Form 3160-5
(June 2015)UNITED STATES
DEPARTMENT OF THE INTERIOR
BUREAU OF LAND MANAGEMENTFORM APPROVED
OMB No. 1004-0137
Expires: January 31, 2018**SUNDRY NOTICES AND REPORTS ON WELLS**
**Do not use this form for proposals to drill or to re-enter an
abandoned well. Use Form 3160-3 (APD) for such proposals.**

8. Well Name and No. CATO SAN ANDRES UNIT #130

Notice of Intent to PA- Procedure

**Cato San Andres Unit 130
30-005-20058
Oxy USA Incorporated
September 22, 2022
Conditions of Approval**

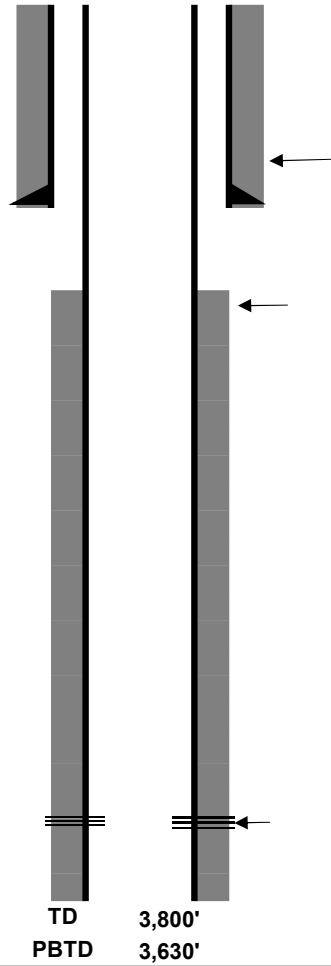
- 1. Operator shall place CIBP at 3,518' (50'-100' above top most perf) and place a minimum of 25 sx of Class C cement on top. WOC and TAG.**
- 2. Operator shall place a balanced Class C cement plug from 1,838' to 1,400' to seal the Yates formation and bottom of Salt. WOC and TAG.**
- 3. Operator shall place a balanced Class C cement plug from 1,275' to 1,163' to seal the top of Salt. WOC and TAG.**

Note: Operator may combine plug 1 and 2 if desired.

- 4. Operator shall perf at 497' and squeeze class c cement to surface to seal the 8-5/8" casing shoe.**
- 5. Dry hole marker must be below ground.**
- 6. Surface reclamation will need to be completed once the well bore has been plugged. Please contact rflores@blm.gov for additional information.**
- 7. See Attached for general plugging stipulations.**
